Technical Service BULLETIN

Title: REAR BRAKE SQUEAL NOISE

Models: '98 – '99 Land Cruiser

BR005-99
BRAKES

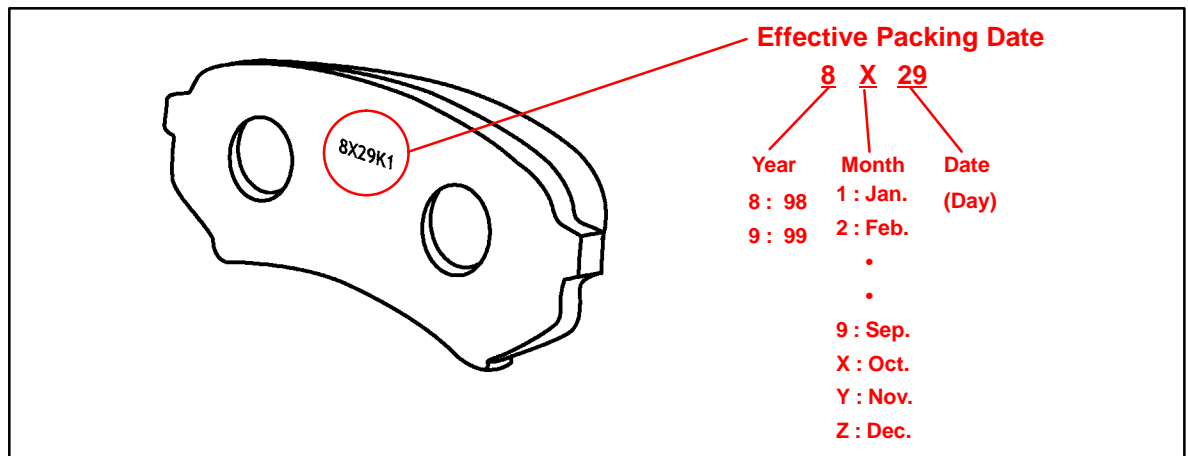
Repair Procedure Check the production date embossed on the metal backing plate of the brake pads, as shown below. Production dates after 8X29 are effective for eliminating the squeal noise.
